# REQUEST FOR COUNCIL ACTION

AGENDA SECTION: PUBLIC HEARINGS	ORIGINATING DEPT: PLANNING	ITEM NO. <b>E-7</b>
ITEM DESCRIPTION: General Development Plan #210 by Big De Development to be known as Bandel North Second and Third. The applicant is proposing to develop approximately 28.74 acres with single attached and detached housing. The property is located east of the Bandel North First Subdivision and north of the Boulder Ridge Second Subdivision and allows for the continuation of Bandel Drive NW.		PREPARED BY: Mitzi A. Baker, Senior Planner
<p>July 14, 2003</p> <p><i>NOTE: See CP&amp;C minutes from previous zone change hearing.</i></p> <p>A revised Plan was submitted following the Planning Commission meeting, to address staff recommended modifications. In response, staff recommends modifications to the conditions, as shown in strikethrough (to delete) and underlined (new) text.</p> <p><b>City Planning and Zoning Commission Recommendation:</b></p> <p>The Planning and Zoning Commission held a public hearing on this item on June 25, 2003.</p> <p>Mr. Haeussinger moved to recommend approval of General Development Plan #210 by Big De Development to be known as Bandel North Second and Thir

**REVIS**  
**GENERAL DEVELOPMENT PLAN**  
**BANDEL NORTH SECOND & THIRD**  
**ROY, MINN.**

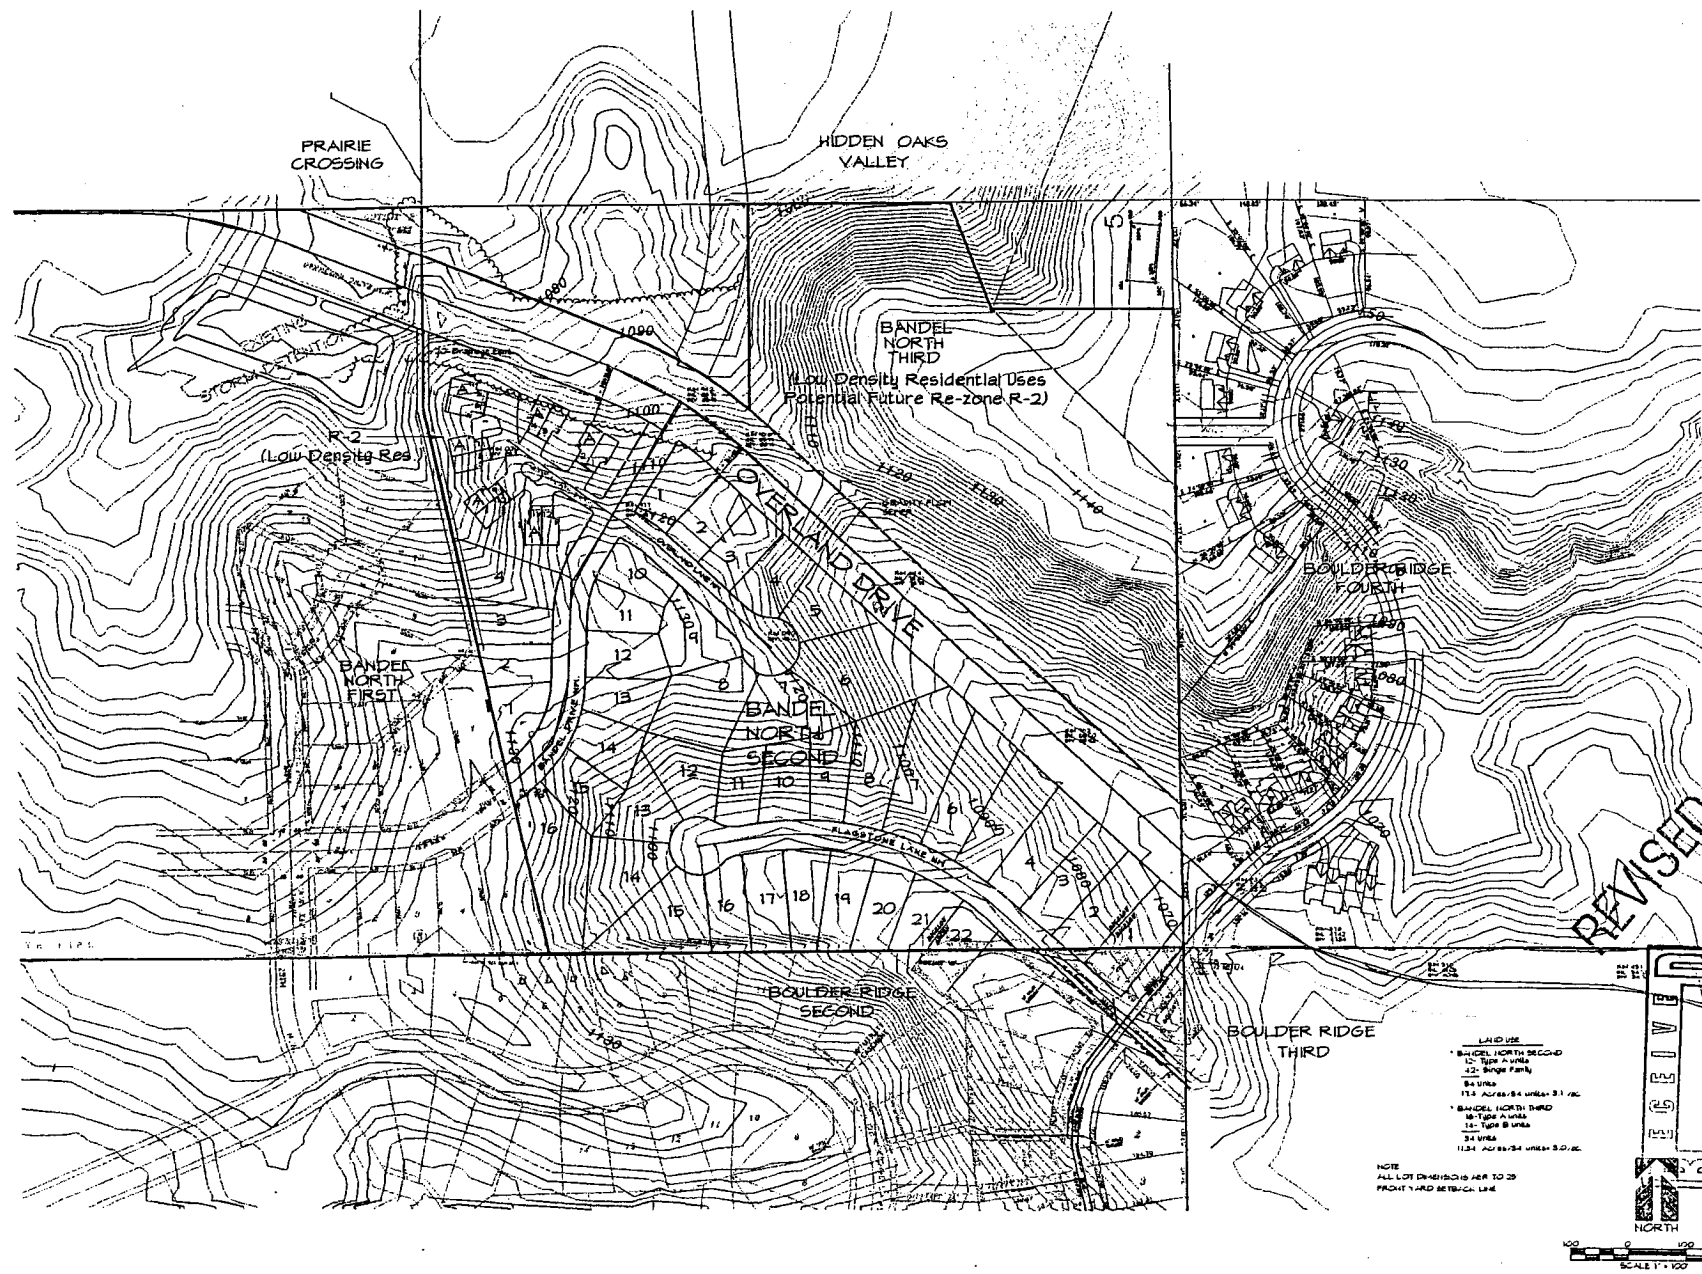
*This applicant owns property on the north side of Overland Drive, which is not included in the GDP. Though a roadway access location is shown the Plan does not identify future land uses and road alignments through the property. The applicant should include that property in this GDP. If it is not included, a separate GDP will be required for that property in the future.*

4. *Parkland dedication shall be met via cash in lieu of land per the June 2, 2003 memorandum from Rochester Park and Recreation.*
5. *If topographically feasible, a mid-block pedestrian connection shall be provided between the two cul-de-sac bulbs.*
6. *The GDP shall be revised to: identify a mid-block pedestrian connection between the two cul-de-sac bulbs; to label the Bandel North Third area as being "Potential" future re-zone to R-2.*
7. *Watermain must be looped through the cul-de-sac streets.*

2. The excluded area of the applicants Property lying north of Overland Dr NW should be included in the GDP.
3. Grading & Drainage Plan approval is required prior to development, and a Stormwater Management charge will apply for the benefit of participation in the City's Storm Water Management Plan (SWMP).

5. Consideration should be given to providing a mid-block connection outlot connecting Overland Ln NW and Flagstone Ln NW.
6. The Owner will be required to dedicate any required mid-block pedestrian connections on separate Outlot(s), and construct the required pedestrian path connections within the Outlot(s).
